### XPS-AMF Replaced by XPS-AK

#### Differentiation

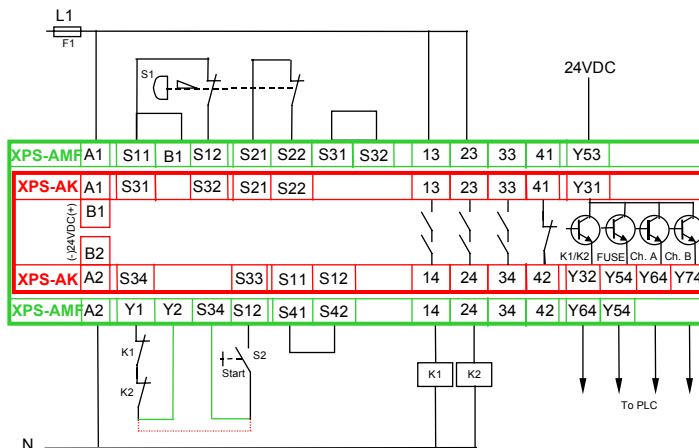
- XPS-AK has 2 extra solid state output for PLC signalling
- XPS-AK has choice of removable plug terminals
- XPS-AMF can be used for Type III A two-hand control monitoring

Monitoring of safety mat with E-stop button

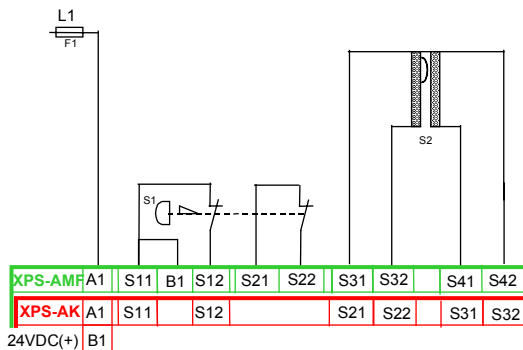
### Schematic Comparison
